ATTACHMENT A

Technical Specification Pages:

# PILGRIM NUCLEAR POWER STATION

Figure 6.2.2

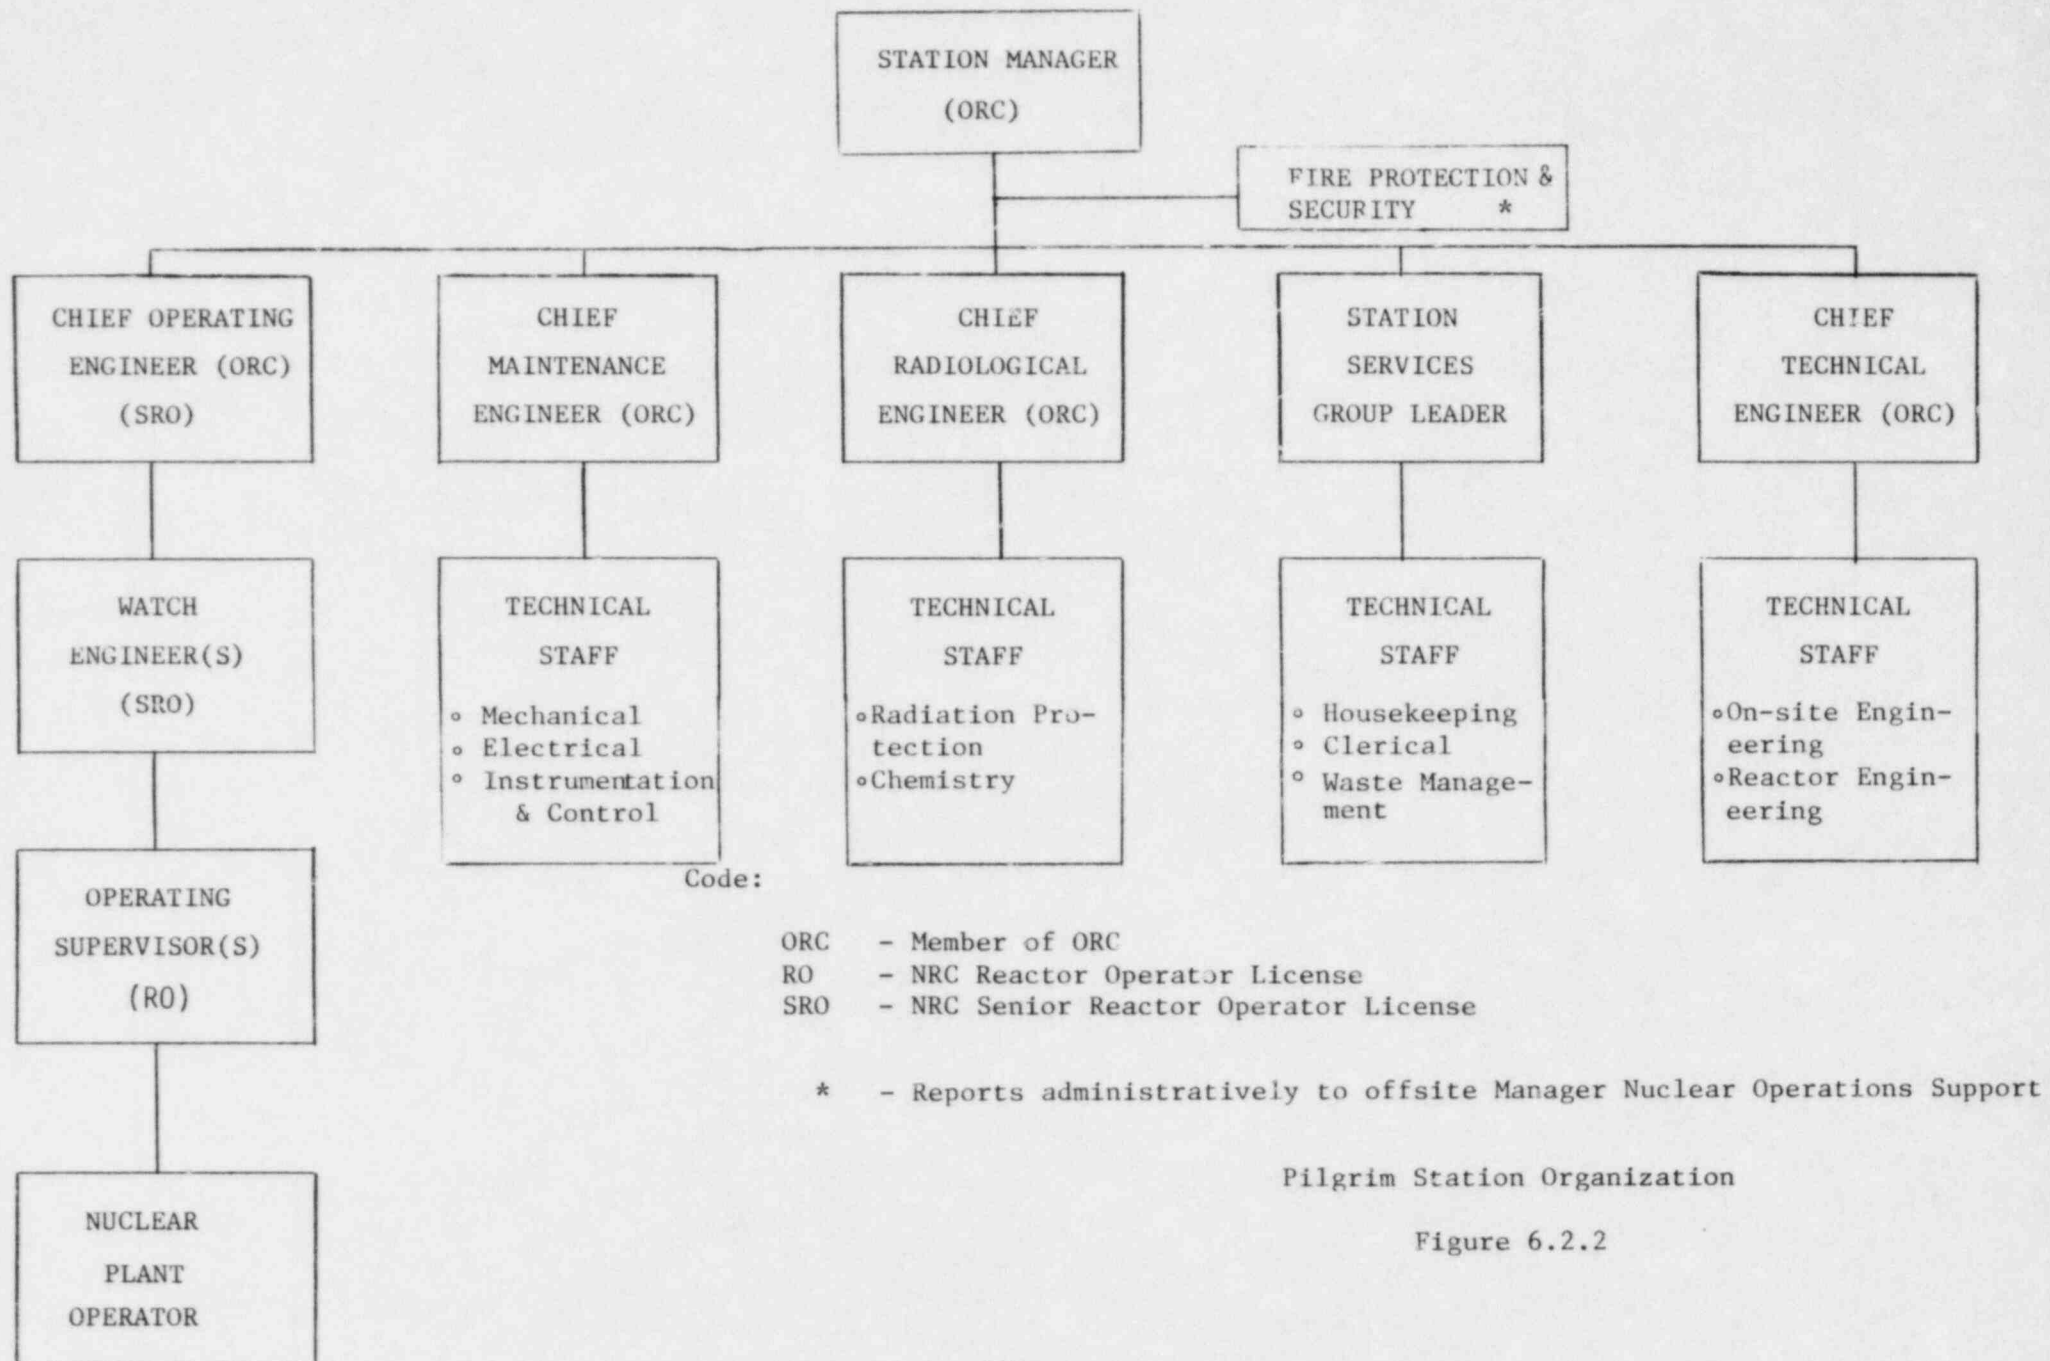
210

213
